**IFB NO 15303-FY23-51
EAST MARKET STREET (ROUTE 7) & BATTLEFIELD PARKWAY INTERCHANGE
LANDSCAPING
ADDENDUM NO. 1**

May 10, 2023

ITEM NO. 1: QUESTIONS AND CLARIFICATIONS

CONSTRUCTION OF A SILT FENCE (WITHOUT WIRE SUPPORT)

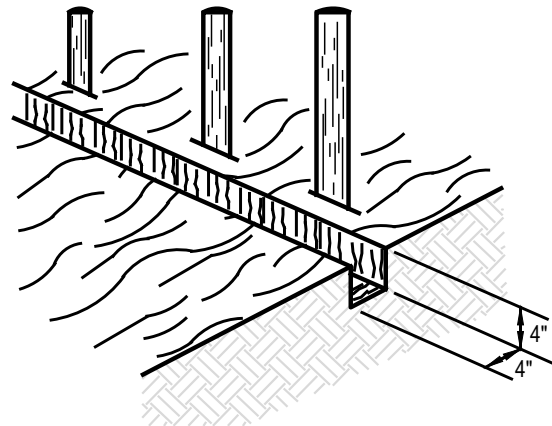
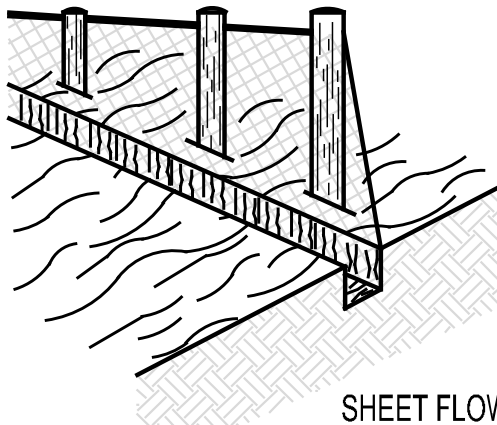
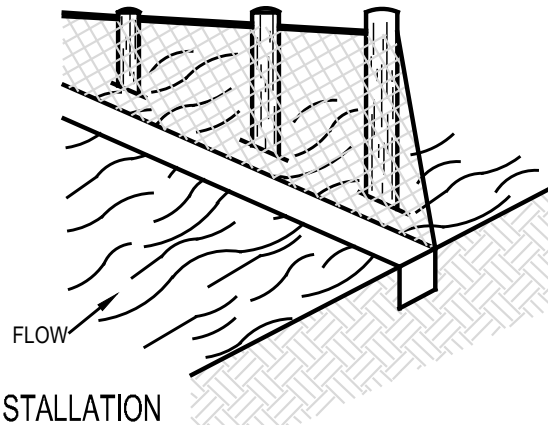
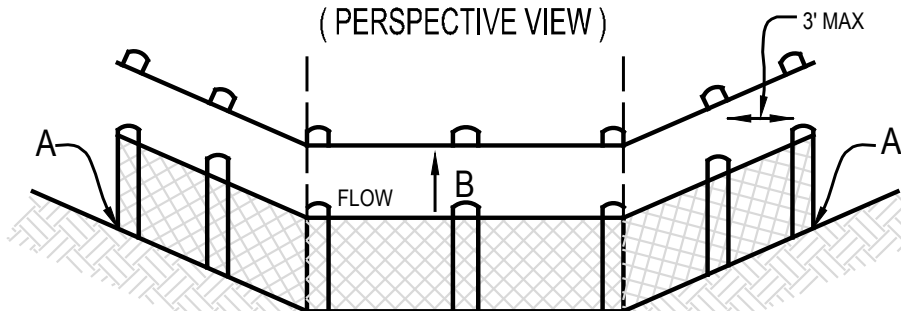
1. QUESTION: Can you provide specifications and details for the following items.
 - Erosion Control / Silt Fence
RESPONSE: Supplemental E&S Detail attached – see Attachment A.
 - Planting Bed Preparation for Shrubs, Ground Covers & Grasses
RESPONSE: Refer to Planting Specifications Section 3.9 in the IFB document.
 - Seed Bed Preparation for Tall Fescue Blend Hydroseeding and Meadow Mix
**RESPONSE:
Tall Fescue Blend - Refer to the BID FORM lines 18 & 19 for the tall fescue preparation. It calls for aeration and slit seeding for 8,404 SY and hydroseeding for 2,874 SY.
